UNIVERSITY OF
MARYLAND
Radiation Facilities
Mohamad Al-Sheikhly, Director

December 18, 2006

Enclosed please find the University of Maryland's response to the request for additional information as it pertains to the Technical Specifications for the Maryland University Training Reactor.

[Signature] Mohamad Al-Sheikhly, Director
University of Maryland Training Reactor
License Number R-70, Docket number 50-166

ATTACHMENT 1: RESPONSE TO QUESTION 84

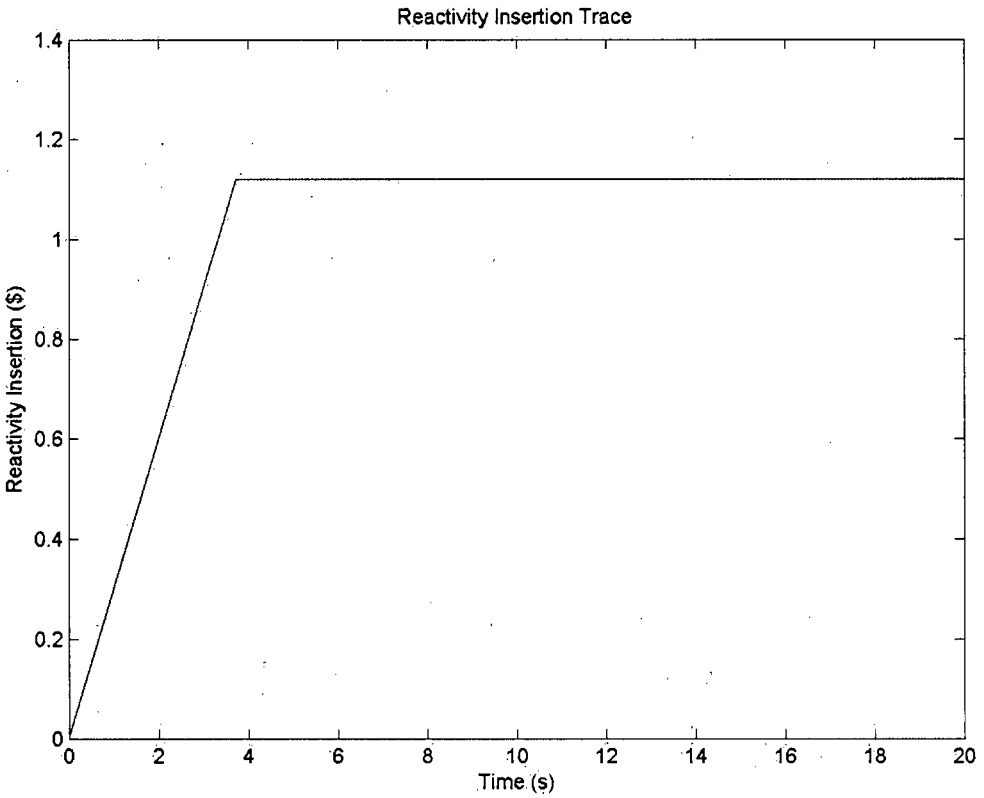
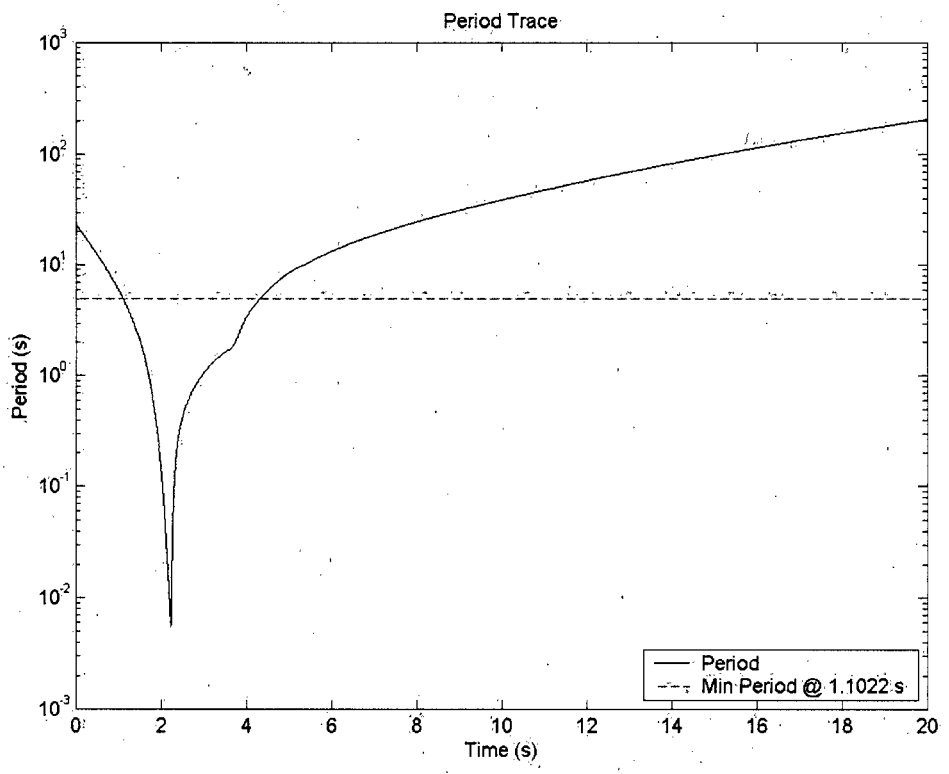
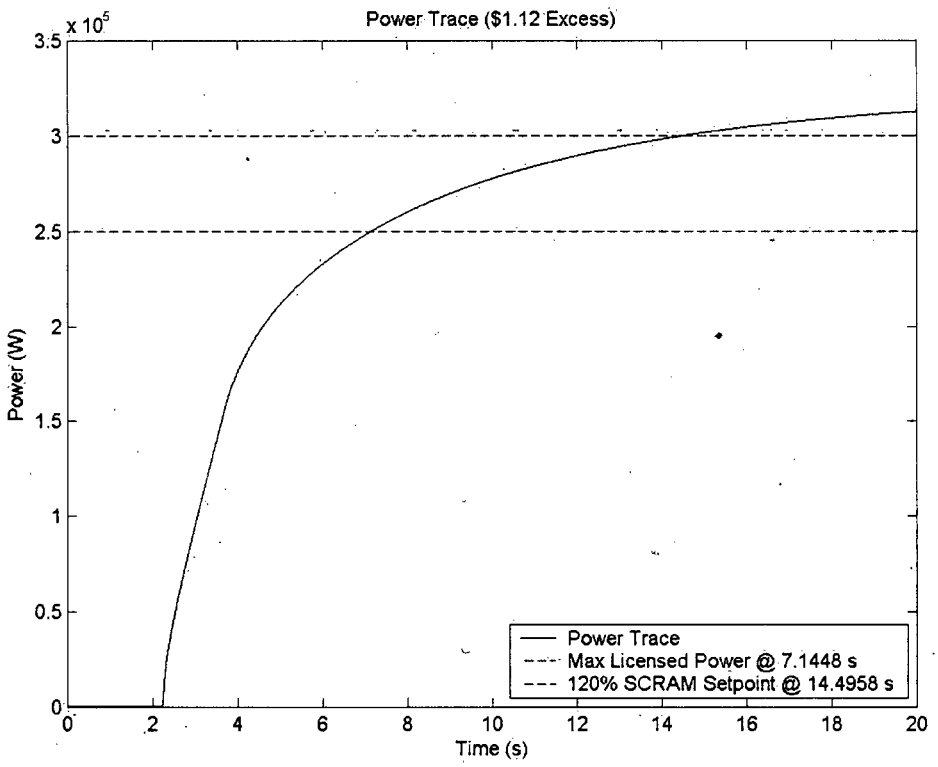
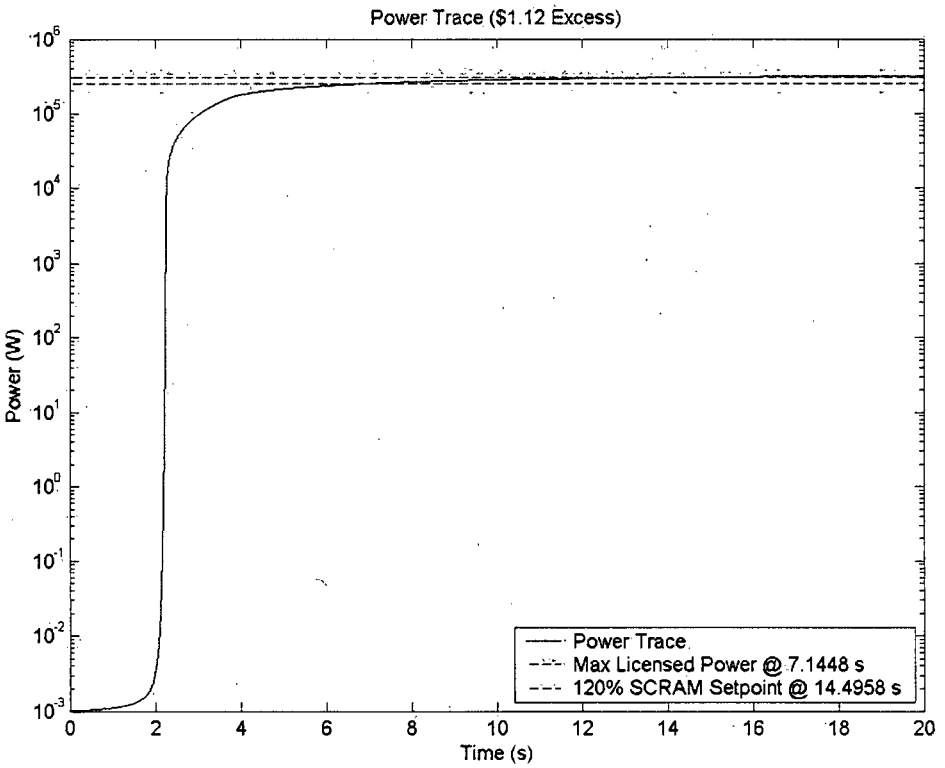
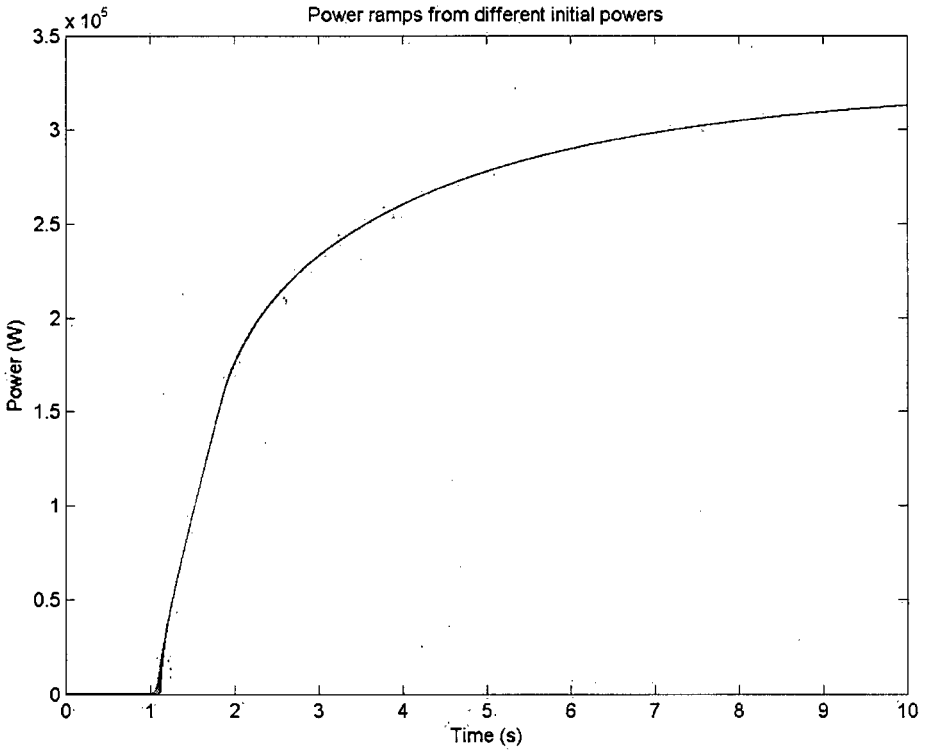
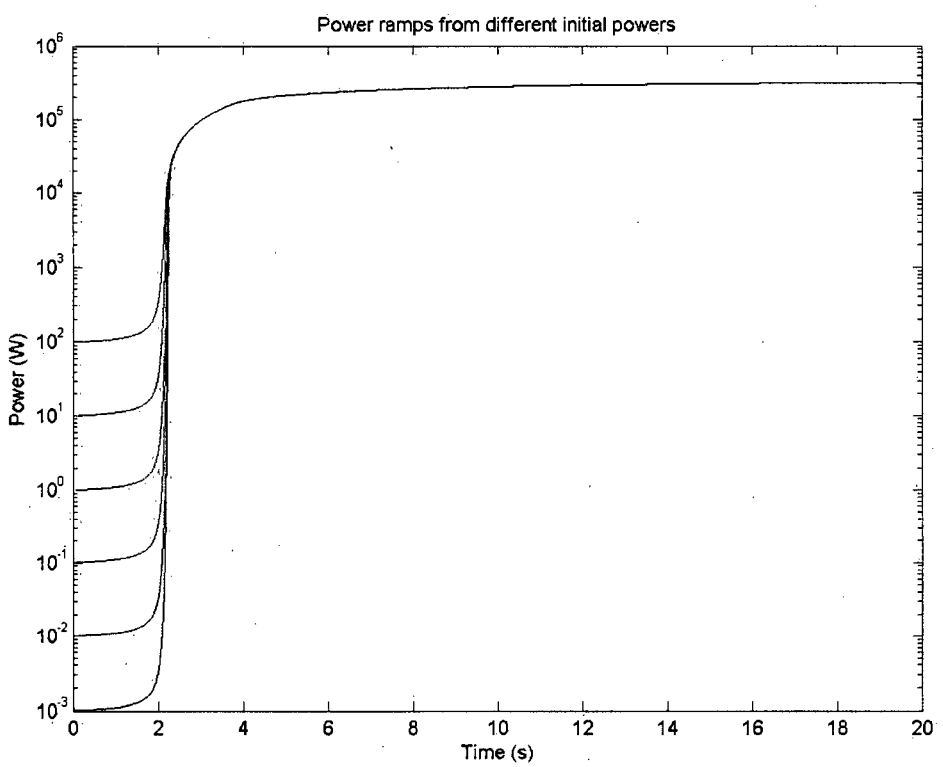
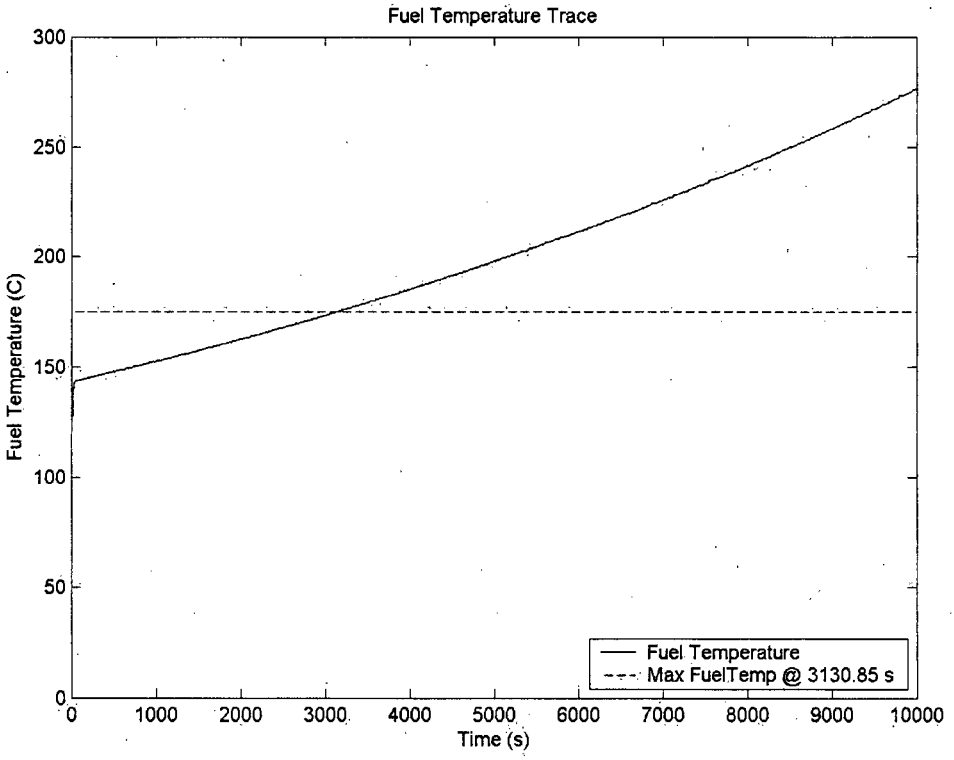
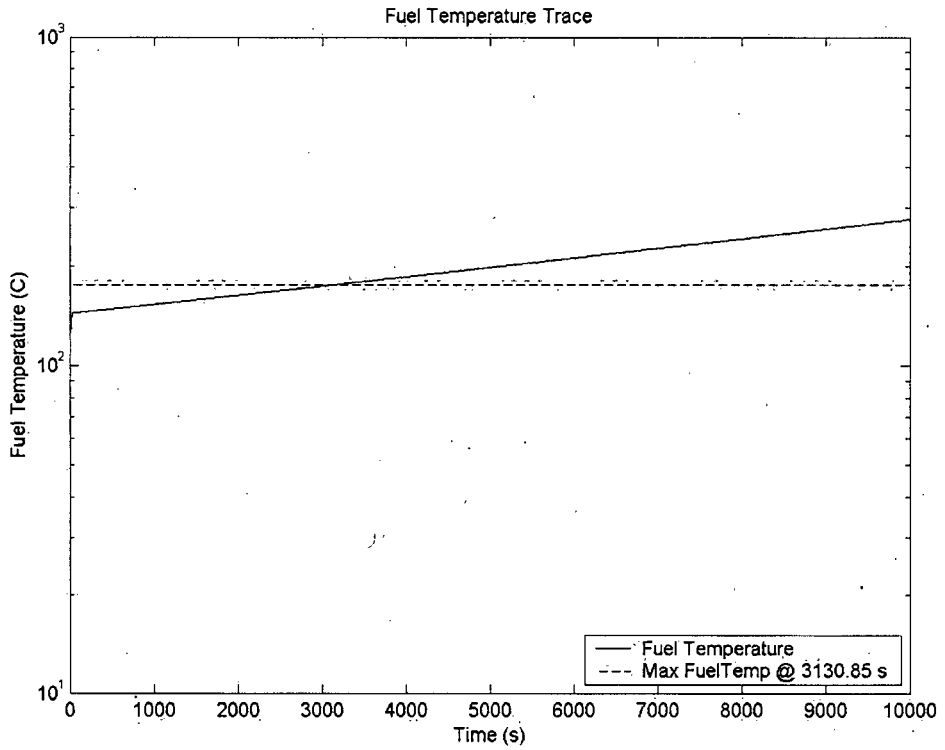
84. TS 3.2.2, REACTOR CONTROL AND SAFETY SYSTEMS. Please discuss the maximum power ramp that would result from adding $0.30 per second of reactivity to the reactor, starting from a low power condition. Also, discuss the reactor safety system response to the reactivity addition, including power overshoot.
See attachment 1:

Four scenarios for $0.30/s insertion will be considered for reactor response with absolutely no human intervention:

Low initial power, period scram at ≤5s period,
Low initial power, no period scram at ≤5s period,
High initial power, power scram at ≥120%,
And High initial power, no power scram at ≥120%.

The first scenario considered is with a low initial power (1mW is first considered) and with the period safety system is in working order, so that any power fluctuations with a period shorter than 5s are scrammed. This is a realistic scenario, as the period safety system is robust, and has been consistent in its operation. Assuming an initial power of 1mW, a $0.30/s reactivity insertion would finish inserting reactivity after 3.7 seconds (Appendix A), but would result in a period scram within 1.2 seconds (Appendix B). Assuming the maximum allowed 1s lapse in time from the scram signal occurs before the Control Rods are inserted, and assuming the full negative reactivity of the Control Rods is inserted instantly, the power would rise to maximum of 3.04W before dropping down to 1.54W in a prompt drop and then exponentially decaying with a negative 80s period.

The second scenario considered is with a low initial power and with an inoperative period safety system, so that any power fluctuations with a period shorter than 5s are not scrammed. Prompt fuel temperature increases as a result of a sharp increase of power would add controllability, and would lessen the increase in power. Assuming an initial power of 1mW, a $0.30/s reactivity insertion would finish inserting reactivity after 3.7 seconds (Appendix A), giving the reactor a minimum period of 0.00562s at 2.23s (Appendix B). At this point, the prompt temperature increases have effectively started to remove excess reactivity at a rate of $0.30/s. The power would continue to rise, which would continue to raise the fuel temperature, until the fuel temperature took away all of the excess reactivity. Eventually, the reactor power would level off. However, there are two independent safety systems, Safety 1 and Safety 2, which would scram the reactor before it got to 120% of full power (300kW). The power would reach 300kW at approximately 14.5s (Appendix C). Assuming the maximum allowed 1s lapse in time from the scram signal occurs before the Control Rods are inserted, and assuming the full negative reactivity of the Control Rods is inserted instantly, the power would rise to maximum of 303.15kW before dropping down to 153.6kW in a prompt drop and then exponentially decaying with a negative 80s period.

The first and second scenarios were considered with an initial power of 1mW. Simulations were done for several initial powers. According to the results, regardless of the initial power, as long as it is below the point of adding heat, the powers will converge to a power trace that levels off and then slowly increases as the moderator is heated up, adding excess reactivity (Appendix D).

The third scenario considered is with a high initial power, and with either of the Safety 1 or Safety 2 safety systems in working order, scramming any power that is greater that or equal to 120% of full power (300kW). This is also a realistic scenario, as both independent systems are robust and have been consistent in their operation. As the initial power increases, the initial fuel temperature also increases, which lowers the excess reactivity. Therefore, this scenario is more realistic than the second, as there is insufficient reactivity to obtain a period shorter than 5s. The period scram setpoint does not come into play in this scenario. The power simply

converges to the low initial power trace, and then scrams at 120% of full power. The scram time will change depending on the initial power.

The fourth scenario is with a high initial power and with both Safety 1 and Safety 2 scram channels inoperable. Like the third scenario, there is insufficient excess reactivity to obtain a period shorter than 5s. In this scenario, the power is finally able to level off at the stable power of approximately 340kW, without being scrammed.

Only in this scenario is the fuel temperature relevant. The fuel temperature mirrors the power level at powers above the point of adding heat. In fact, without units or scales, it would be difficult to tell the difference between their graphs. At this point, the water surrounding the core is heated up, and reactivity is effectively inserted through the positive moderator reactivity coefficient. The reactor slowly rises in power until there is a fuel temperature scram at 175°C. This scram occurs at approximately 3130s after the beginning of the reactivity insertion (Appendix E).

Figure 6.1: MUTR Position In University Of Maryland Structure

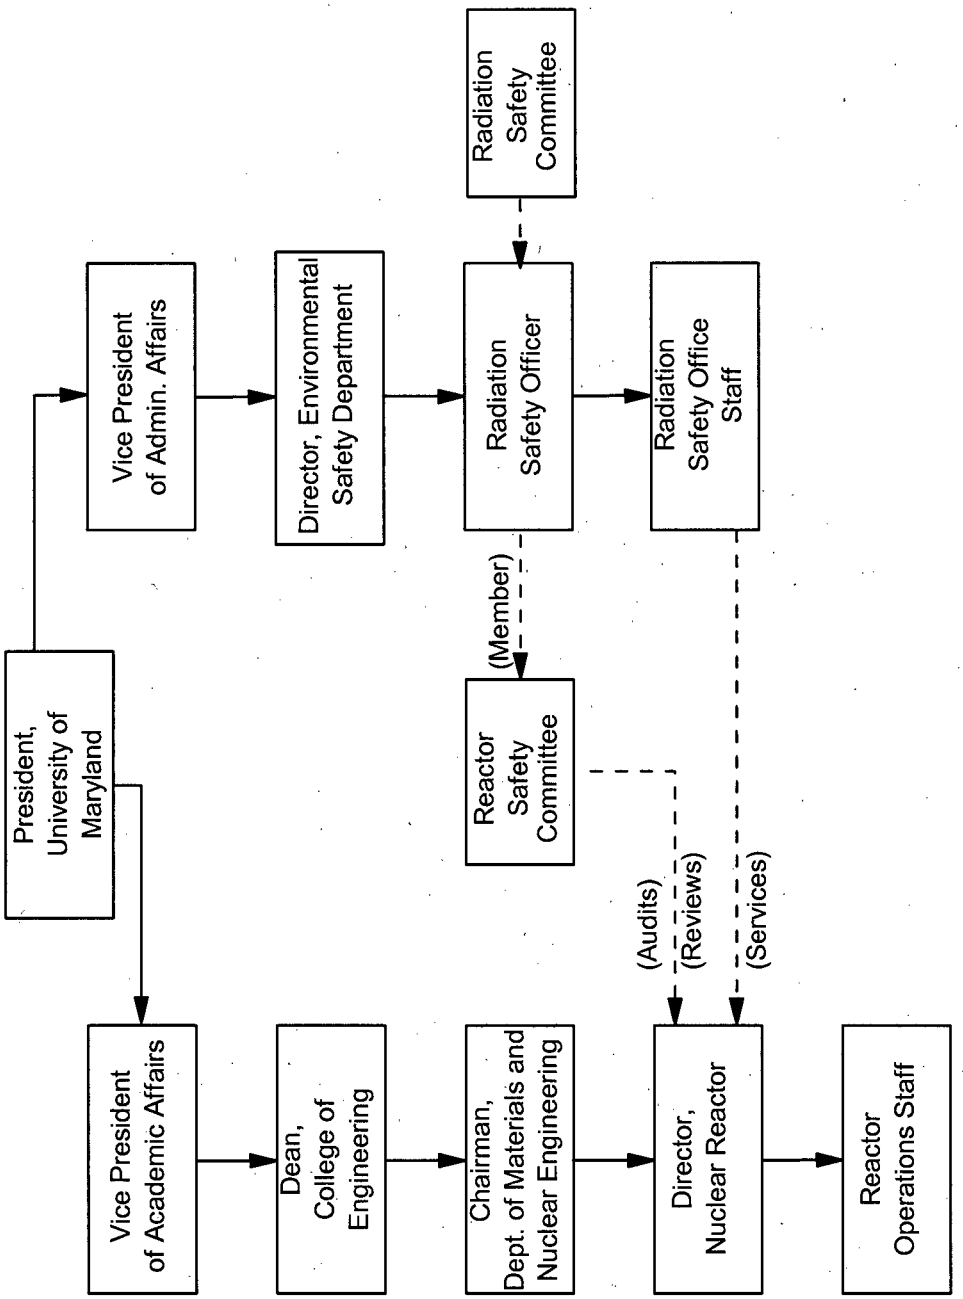
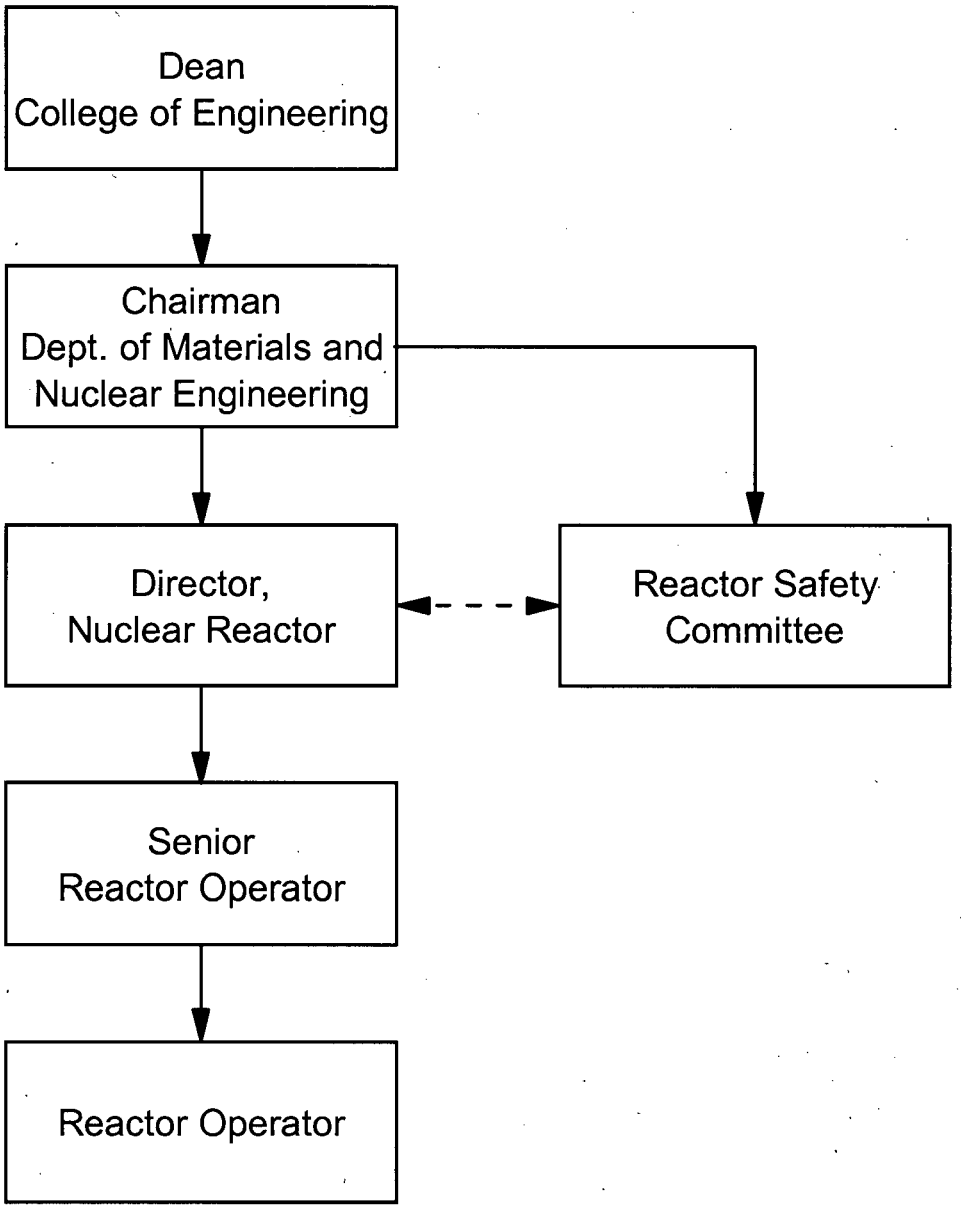
103. TS Figure 6.1 and 6.2. Please clarify the meaning of solid and dotted lines on the structure diagrams. The solid line shown on Figure 6.2 between the Chairman of the Department of Materials and Nuclear Engineering and the Reactor Safety Committee is not on Figure 6.1 (similar comments on SAR Figures 12.1 and 12.2). Please explain.
Following the example of ANSI/ANS 15.1, the dotted lines signify communication lines where the solid lines indicate reporting lines.
